Louisiana Energy Services, LLC
National Enrichment Facility
NRC Docket No. 70-3103

Subject: RAI response on NEF License Amendment Request LAR-09-02,
Organizational Change affecting the Quality Assurance Program Description

Enclosure 1
LES Responses to NRC RAI on the QA organizational amendment

Figure 2.1-1 LES Corporate, Design and Construction Organization

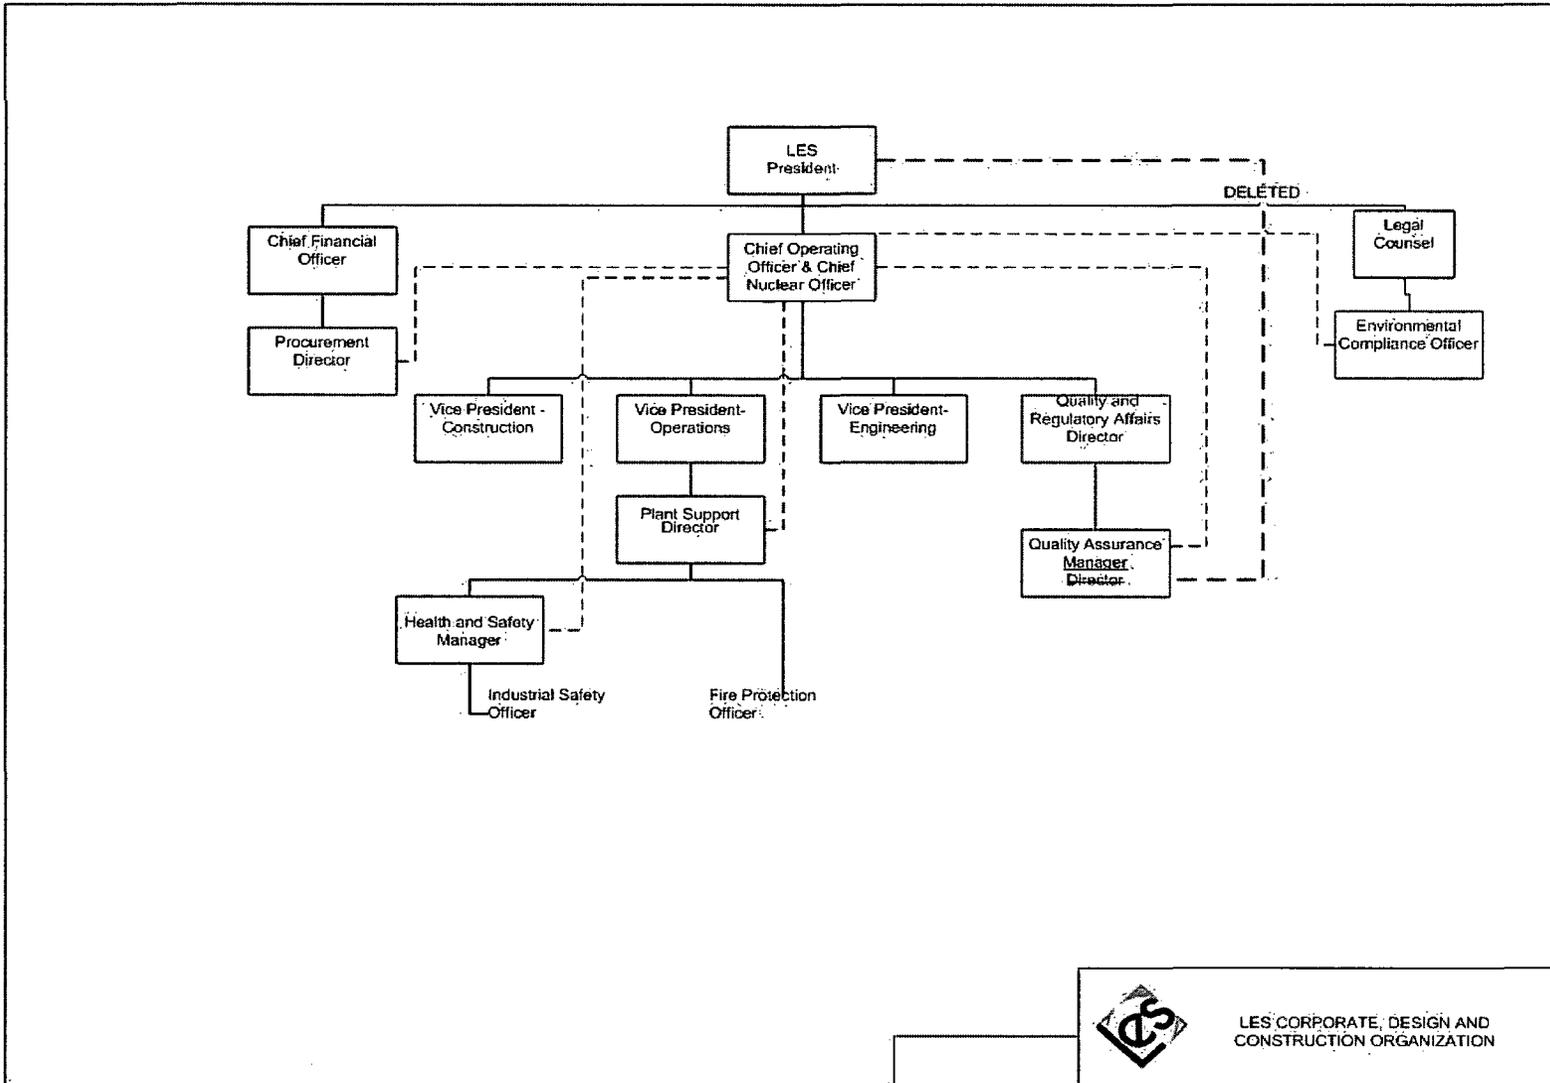
2. SAR, Chapter 2, Figure 2.2-1, p. 2.5-2

Clarify in the organizational chart depicted in Figure 2.1-1, how lines of authority and organizational freedom are maintained between the QA Manager, QRAD, and the Chief Operating Officer and Chief Nuclear Officer.

LES Response: The Chief Operating Officer and Chief Nuclear Officer is ultimately responsible for the design, construction, commissioning and operation of the facility. The Quality Manager is being provided a reporting relationship for specific stop work authority, as described in the response to RAI #1 above, in addition to a relationship with

the Chief Operating Officer and Chief Nuclear Officer for quality concerns with the Performance Assessment & Feedback organization. The Performance Assessment & Feedback organization is responsible for the corrective action program and reports to the same manager as the Quality Assurance organization. Providing a relationship to the Chief Operating Officer and Chief Nuclear Officer ensures the Quality Assurance Manager has sufficient independence for all issues affecting quality including the corrective action program.
